## Product Change Notification / NTDO-11BSAL752

CCB 5092 Final Notice: Qualification of MMT as an additional assembly site for selected HV5523K7, HV5623K7, HV5522K7 and HV5622K7 device families available in 44L WQFN (7x7x0.8mm) package.

**CCB 5092**  
**Pre and Post Change Summary**  
**PCN#: NTDO-11BSAL752**

## NSEB

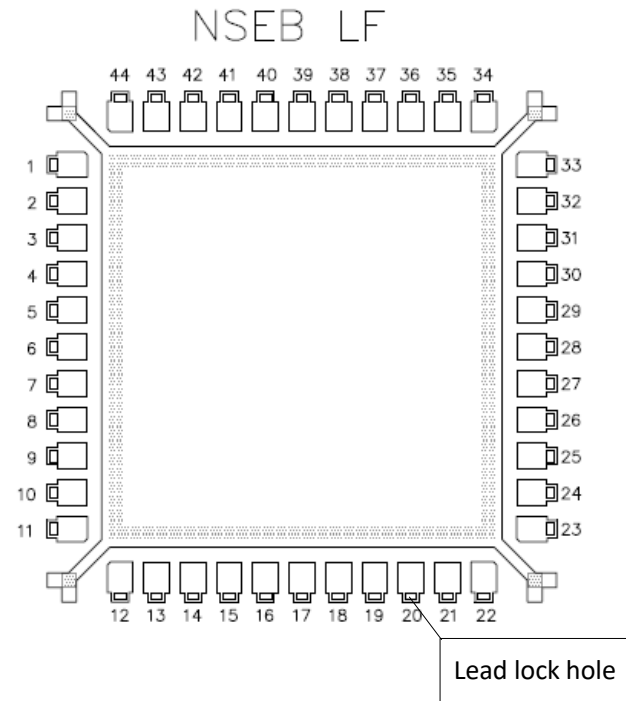
Lead frame material	EFTEC-64T
Lead frame Paddle size	217x 217 mils
Lead-lock (Locking Hole)	Yes

## CARC

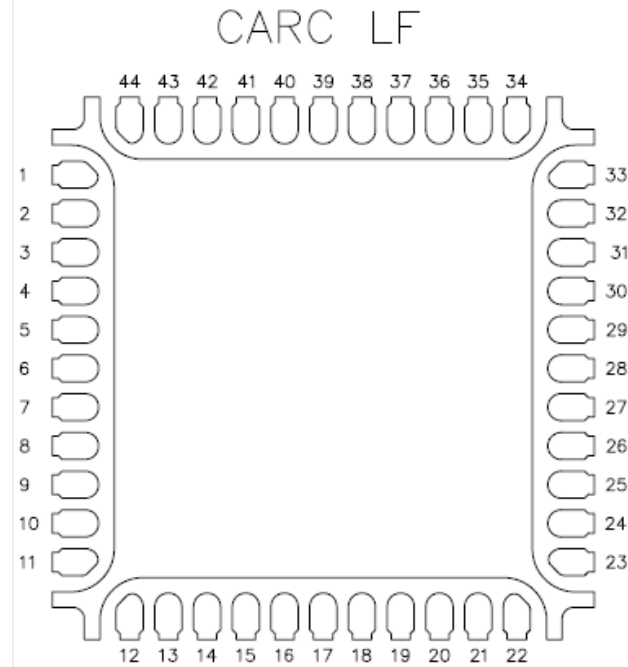
Lead frame material	A194
Lead frame Paddle size	213x213 mils
Lead-lock (Locking Hole)	No

## MMT

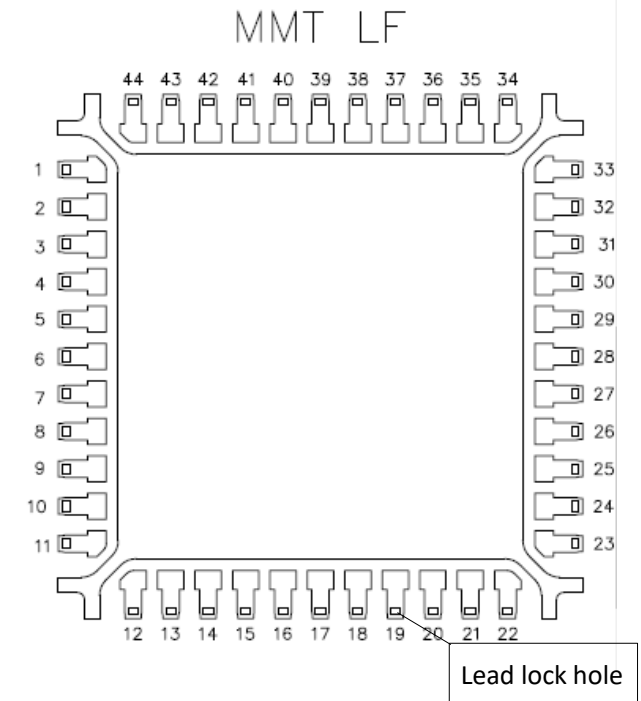
Lead frame material	A194
Lead frame Paddle size	213x213 mils
Lead-lock (Locking Hole)	Yes

Note: Mold compound material fills the leadlock hole, which provides improved protection against moisture penetration along the edge of the leads (pins) of the package.
